Current Zoning: B-1 (neighborhood business)
Proposed Zoning: MUDD-O (mixed use development, optional) with three-year vested rights

Approximately 0.34 acres located at the southwest intersection of Seigle Avenue and Belmont Avenue, north of Harrill Street.

The petition proposes rezone a lot previously used as an auto car garage to allow the construction of a 9,000-square foot mixed-use building residential and nonresidential uses.

PLANNING STAFF REVIEW

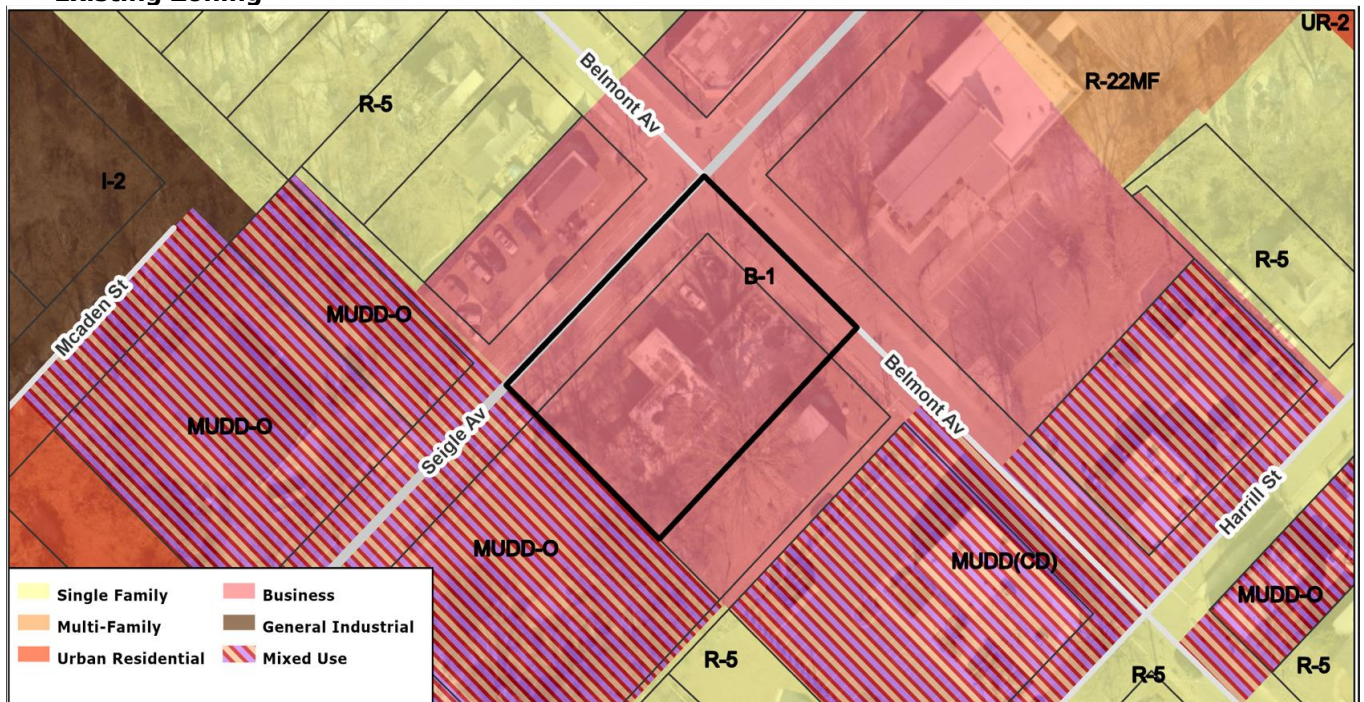
Existing curb and gutter can remain in existing location but label and dimension the future curb and gutter location from the centerline for each road on the site plan. Addressed

- ~~1. The site plan shall label and dimension the right of way from the road centerline. Site plan shows 25' to centerline but does not show the existing 50' from centerline. Label and dimension the existing 50' right of way from centerline of road.~~ Addressed

- ~~2. CDOT requests petitioner commit to 8' sidewalk and place Streets Map streetscape behind future curb location.~~ Addressed
- ~~3. Add a conditional note specifying "A Right of Way Encroachment Agreement is required for the installation of any non-standard item(s) (irrigation systems, decorative concrete pavement, brick pavers, etc.) within a proposed/existing City-maintained street right of way by a private individual, group, business, or homeowner's/business association. An encroachment agreement must be approved by CDOT prior to construction/installation. Contact CDOT for additional information concerning cost, submittal, and liability insurance coverage requirements."~~ Addressed

- ~~4. Add a conditional note specifying "the Petitioner shall dedicate and convey in fee simple all rights-of-way to the City before the site's first building certificate of occupancy is issued. CDOT requests rights-of-way set at 2' behind back of sidewalk where feasible."~~ Addressed

- ~~5. Petitioner should revise the site plan and conditional notes to show sidewalk utility easement on plans behind proposed sidewalk.~~ Addressed

6. ~~Petitioner should revise the site plan and conditional notes to show 10x10 triangles behind the sidewalk.~~ **Addressed**

7. ~~Review urban tree requirements. While the 10' no build zone can be counted towards tree save there must still be a minimum of 10' of replanted tree save. (20' total width) Trees cannot be planted within 10' of a structure/retaining wall. Utilities such as transformers are not permitted within trees save or amenitized tree save.~~ **Petitioner response:** Petitioner has reconfigured preliminary off-street parking layout to accommodate 10' distance & 10' width requirements. Potential transformer locations have been moved outside of amenitized tree save (See Site Plan on RZP-01, Rev 2). **Update:** Per discussion, the best option for tree save at this point will be provided per the ordinance and removed "potential tree save" designation for areas that we not sure would even qualify as tree save and review that during development plan review. **Addressed**

8. ~~Trees outside of the property line cannot count towards any requirements. Trees must be completely on the property to count towards requirements.~~ **Petitioner Response:** Petitioner commits to protecting the five "property line trees" on southern property line. (See Note 2D, RZP-01 Site Plan, Rev 2). Petitioner is open to amending the wording of this Optional Provision to suit Urban Forestry, if desired. Note: as provided to Henry Kunzig via 4-17-23 email, center measurement of 12" oak is completely on property at dbh. Updated Tree Survey uploaded to ACCELA. Petitioner is willing to reduce protection to just that tree, if desired. **Update:** While trees on the property line can be protected, trees not completely located on the property cannot be counted towards meeting tree save requirements. **Addressed**

9. ~~Please confirm if residential is proposed as it is not specified under proposed uses.~~ **Addressed**
10. ~~Under proposed list of permitted uses, please modify Type EDEE Types 1 and 2 to note subject to ordinance requirements.~~ **Addressed**
11. ~~Under proposed list of permitted uses, please modify breweries to note subject to ordinance requirements.~~ **Addressed**
12. ~~Include minimum % brick required on ground floor.~~ **Addressed**
13. ~~Include minimum area for public open space required.~~ **Addressed**
14. ~~The precedent imagery is showing a structure constructed with brick. Recommend brick being used as a primary building material on the first floor.~~ **Addressed**
